PLANNING DEPARTMENT STAFF REPORT AND FINDINGS

ROLLING MEADOWS MINOR PARTITION – PRELIMINARY PARTITION APPROVAL (File MP 23–16)

Preliminary Partition Plan Map

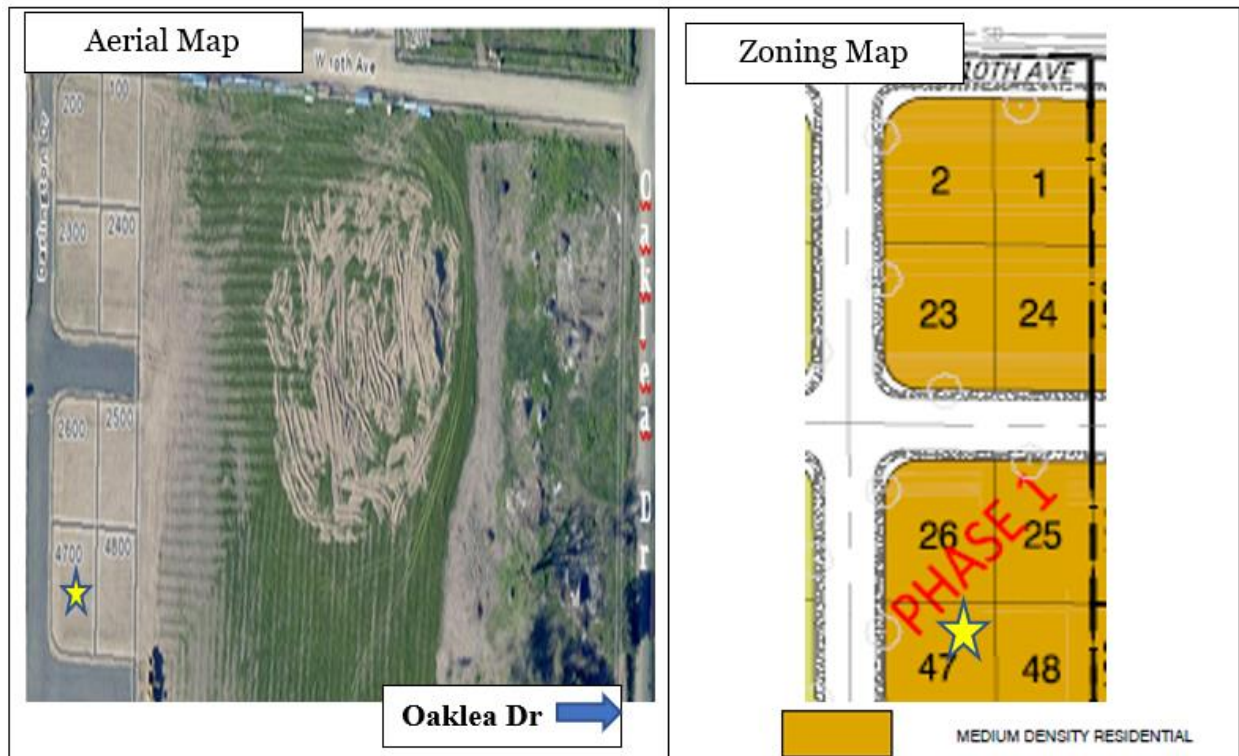
Finding 9: The preliminary plan has the date, north point and scale of the drawing. The dimensions of the property are adequately identified as adjacent tax lots are identified and numbered. The legal description of the property is Lot 47, Rolling Meadows PUD Phase 1. Neither the preliminary partition plan nor the supplemental materials identify the assessor's account number (Act #1914516).

Finding 10: The name and address of the owner/partitioner is present on the preliminary plan and its telephone number. However, the telephone number is included on the application form. The applicant's representative's name and address is listed on the preliminary plan as is Marcus Cross, the applicant's surveyor.

Finding 12: The preliminary plan depicts the layout of the proposed parcels and their number. The complete dimension of each parcel is included and their square footage.

Finding 13: The preliminary plan shows that the lot is vacant. The preliminary plan lists the setback standards associated with the R2 Zone.

Finding 14: The preliminary plan shows the location of two dedicated water easements and a public utility easement. These easements were dedicated as part of the approval of Phase 1 of the Rolling Meadows Subdivision.

Finding 33: The preliminary plan shows a 5' x 15' water easement, a 5' x 7.5' water easement and a public utility easement; all dedicated to the city.

Finding 34: No back yard abuts an existing or planned street and therefore no perimeter fence is required. The preliminary plan does not identify any proposed fencing.

Condition of Approval #1: The final plat must show all easements. All easements must be recorded and the public utility easements dedicated to the City prior to final plat approval.
